CPUC SUBSTATION AUDIT FINDINGS

PG&E Pismo Beach Headquarters

October 14 – 18, 2024

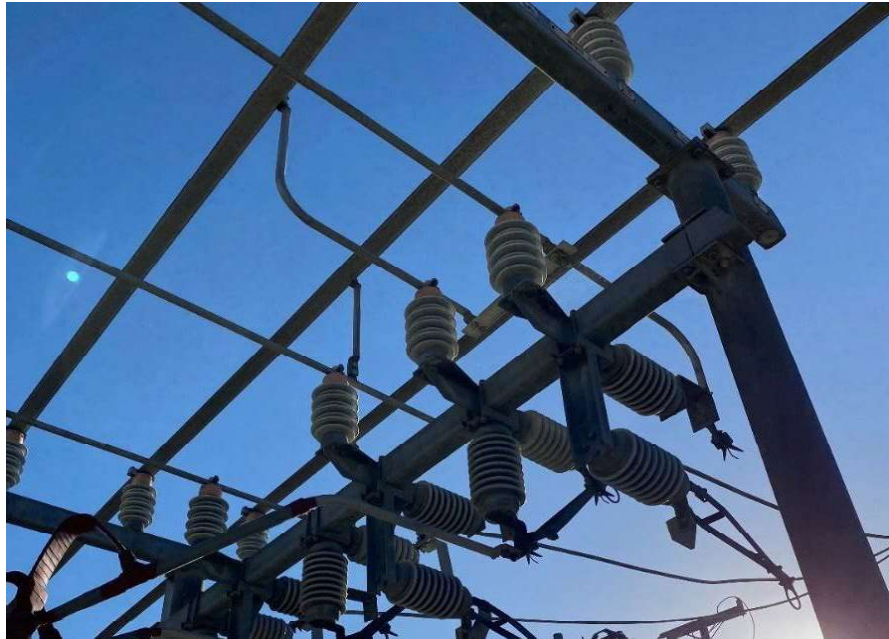
- 1.1. There are bird nests on Transformer Bank 2. PG&E has existing Notification #126370460 for this issue.

We agree a bird's nest was present on Transformer Bank 2 at Oceano Sub. This nonconformance has a pre-existing notification 126370460 established in our system of record SAP prior to the field audit. We do not agree that this finding qualifies as a violation of GO 174, Rule 12 since this notification is being worked in accordance with our maintenance procedures and is not past due.

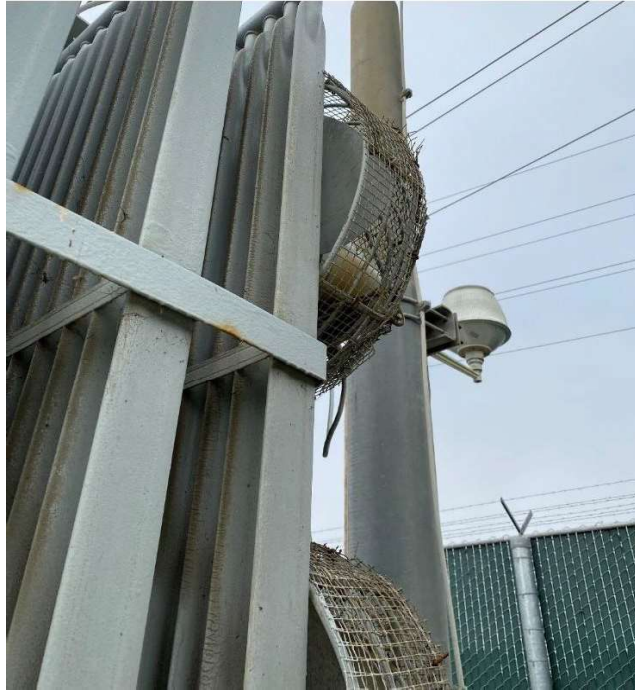
3.3 There are bird nests underneath the current transformers on CB 12 (left) and CB 32 (right). PG&E has existing Notification #129670237 for these issues.

We agree a bird's nest was present on CB 12 and CB 32 at Atascadero Sub. This nonconformance has a pre-existing notification 129670237 established in our system of record SAP prior to the field audit. We do not agree that this finding qualifies as a violation of GO 174, Rule 12 since this notification is being worked in accordance with our maintenance procedures and is not past due.

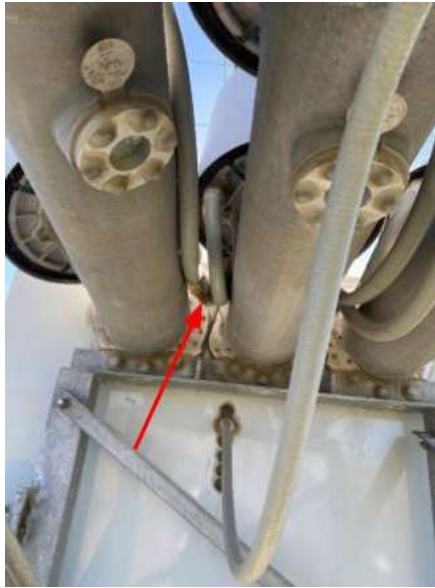
- 5.1. There are bird nests underneath CB 32 (left) and CB 42 (right). PG&E immediately created the Notifications #129692079 and #129692078 to address these issues.

We agree with the findings of the Bird's nest on CB 32 and CB 42 at Cayucos Substation. We created notifications 129692079 and 129692078; these will be completed based on current work prioritization.

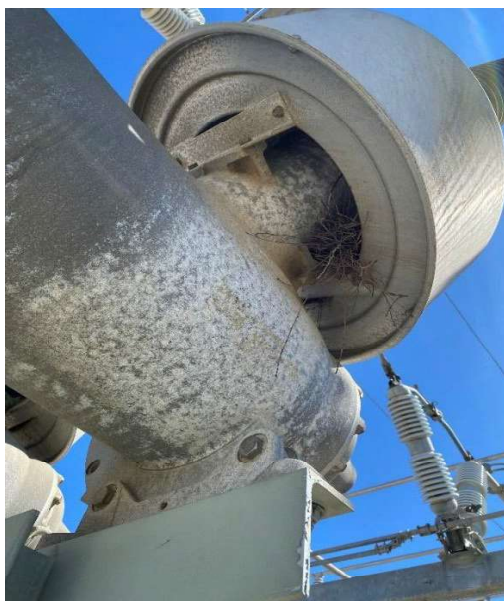
- 8.3. The bottom row of the display screen for the transformer oil temperature monitor is damaged and makes reading the values difficult.

We agree with the finding of the impacted display on the Barrington LCD screen at Zaca Substation. We created notification 130717745, which will be completed based on current work prioritization and material availability.

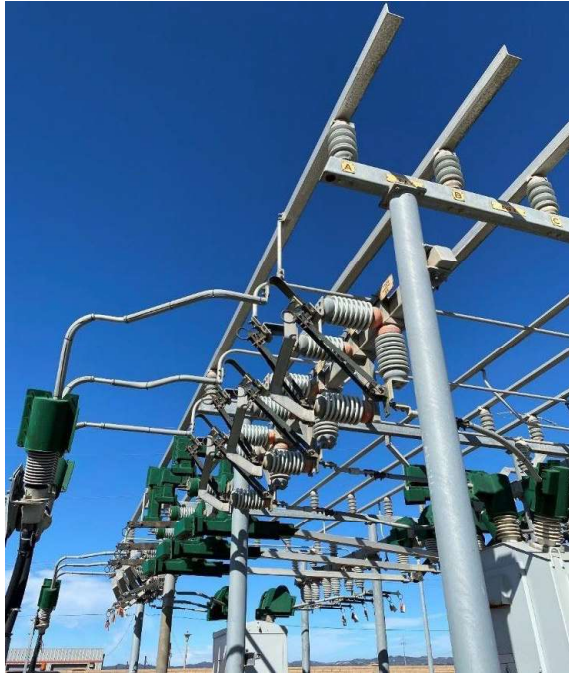
- 9.1. There are bird nests under CB 152 (left) and CB 122 (right). PG&E has existing Notification # 129658296 for these issues.

We agree a bird's nest was present on CB 152 at Cabrillo Sub. This nonconformance has a pre-existing notification 129658296 established in our system of record SAP prior to the field audit. We do not agree that this finding qualifies as a violation of GO 174, Rule 12 since this notification is being worked in accordance with our maintenance procedures and is not past due.

We agree with the finding of the bird's nest on CB 122 at Cabrillo Substation and created notification 130717746, which will be completed based on current work prioritization and material availability.

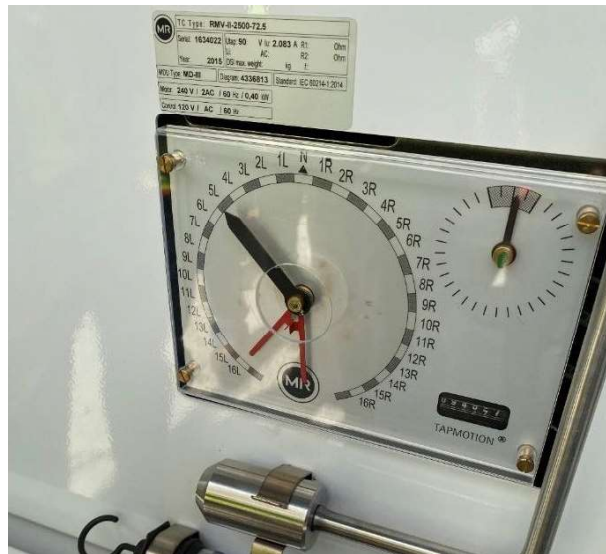
- 11.3. The counter on CB 152 is faded. PG&E has existing Notification #125554093 for this issue.

We agree a faded counter was present on CB 152 at Sisquoc Sub. This nonconformance has a pre-existing notification 125554093 established in our system of record SAP prior to the field audit. We do not agree that this finding qualifies as a violation of GO 174, Rule 12 since this notification was being worked in accordance with our maintenance procedures and was not past due. However, this work was completed on December 2, 2024.
